# STEPHEN A. BEAN MUNICIPAL AIRFIELD RANGELEY, MAINE

# AIRPORT LAYOUT PLAN

OCTOBER 31, 2017

RE: (See attached Table 1 for referenced case(s))  
ALP 7460 No Objection Letter  
\*\*FINAL DETERMINATION\*\*

SHEET TITLE  
 ULTIMATE AIRPORT  
 LAYOUT PLAN

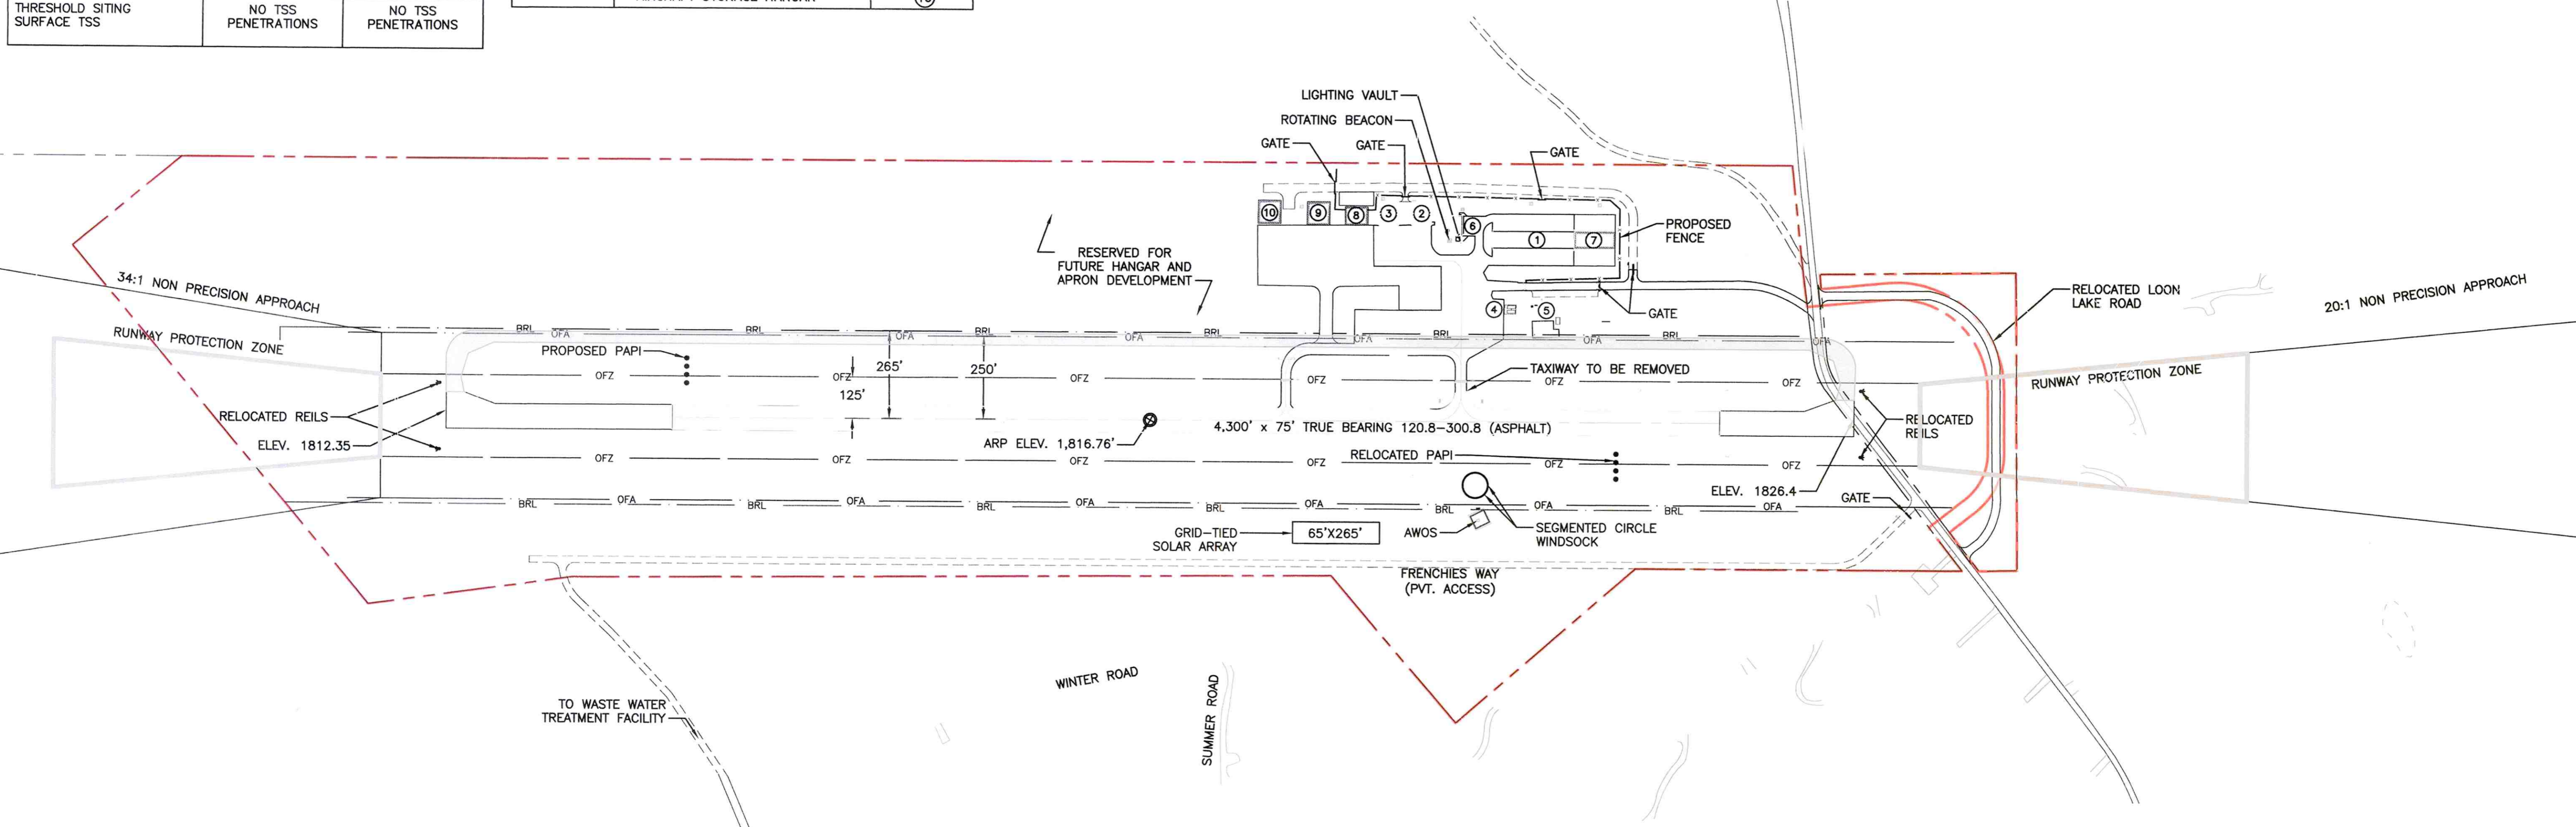
Airport Layout Plans (ALPs) are long term planning initiatives and limited in scope, therefore conceptual in nature. ALP approval does not constitute blanket approval of new structures given the absence of detailed structure information required for comprehensive review. All new structures require separate aeronautical study submissions with detailed building plans for independent study. Ensure appropriate Notice of Construction/ Alteration, FAA 7460-1, is filed for review of all permanent and temporary structures. VISAIDS: Incorrect Lat/Long Coordinates for the proposed RWY 14-32 ends The lat/long coordinates listed in the Runway Data

Table for the proposed RWY 14-32 ends are incorrect. Revise Runway Data Table to list the correct lat/long coordinates for the proposed RWY 14-32 ends. 2. Proposed RWY 14 PAPI/ Relocated RW 14 REILs a) No object shall penetrate the Obstacle Clearance Surface (OCS) for the proposed RWY 14 PAPI. b) Future coordination will be required with the FAA National Flight Data Center (NFDC) to complete a "Pending" VGSI Data Form for the proposed RWY 14 PAPI. c) Future coordination will be required with the FAA Flight Inspection Services to flight check the proposed RWY 14 PAPI along with the relocated RWY 14 REILs. 3. Relocated RWY 32 PAPI & REILs a) No object shall penetrate the Obstacle Clearance Surface (OCS) for the relocated RWY 32 PAPI. b) Future coordination will be required with the FAA National Flight Data Center (NFDC) to submit an updated VGSI Data Form for the relocated RWY 32 PAPI. c) Future coordination will be required with the FAA Flight Inspection Services to flight check the relocated RWY 32 PAPI along with the relocated RWY 32 REILs. WEATHER: Comments: ALP for Steven A Bean Municipal Airport shows grid tied solar array on ALP and within 500 ft. of the 8B0 AWOS, this would be a violation of the AWOS siting 6560.20. Proposed array CANNOT exceed a height of 1824 ft. AMSL, this is based on an elevation in the vicinity of AWOS of 1809 ft. A review of existing conditions near the 8B0 AWOS shows tree growth within 500 ft. of AWOS this is also a violation of siting 6560.20; trees should be removed if they have exceeded a height of 1824 AMSL or are higher than 15 ft. below AWOS wind sensor. Flight Services Coordination: For AVN flight inspection, POC is Georgia Hines, Flight Inspection Services, 405-954-8545 FAA ATO Planning & Requirements (P&R) POC is Tim Wheeler, 404-305-7307
